Development Facilitation Team (DFT) – Review Comments

DRB Project No: PR-2023-008235 Date: 3/27/2024 Agenda Item: #6 Zone Atlas Page: L-15

Legal Description: Tract 1-B University Village

Request: Subdivide One Existing lot into 2 new lots

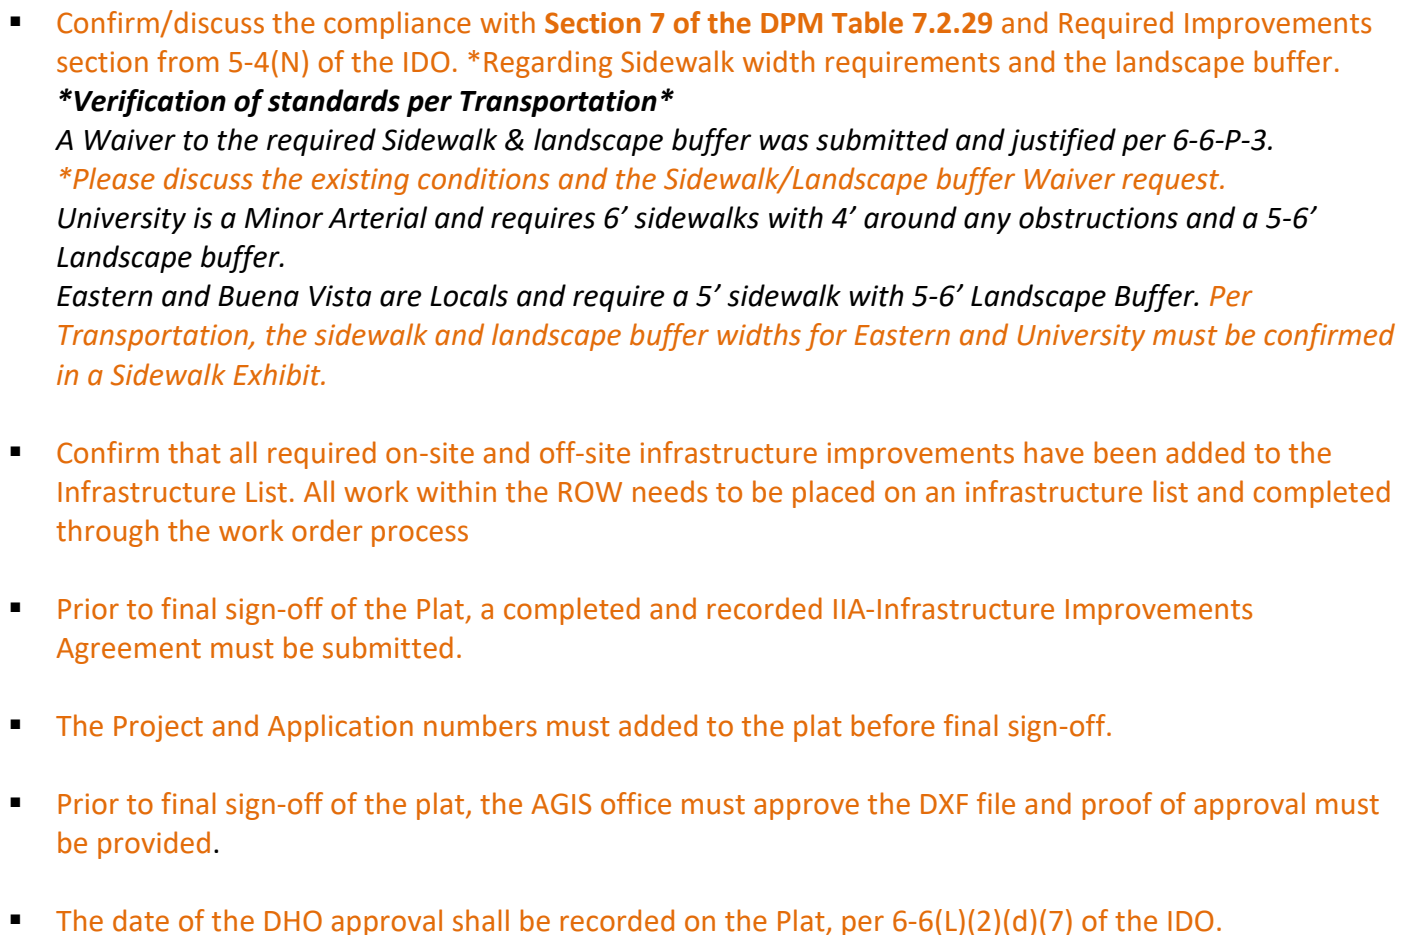
- Confirm/discuss the details of the proposed Preliminary/Final plat; ROW, Easements, lot line adjustment.
- Please clarify the lots that will be included in the platting application (see AGIS maps below:)
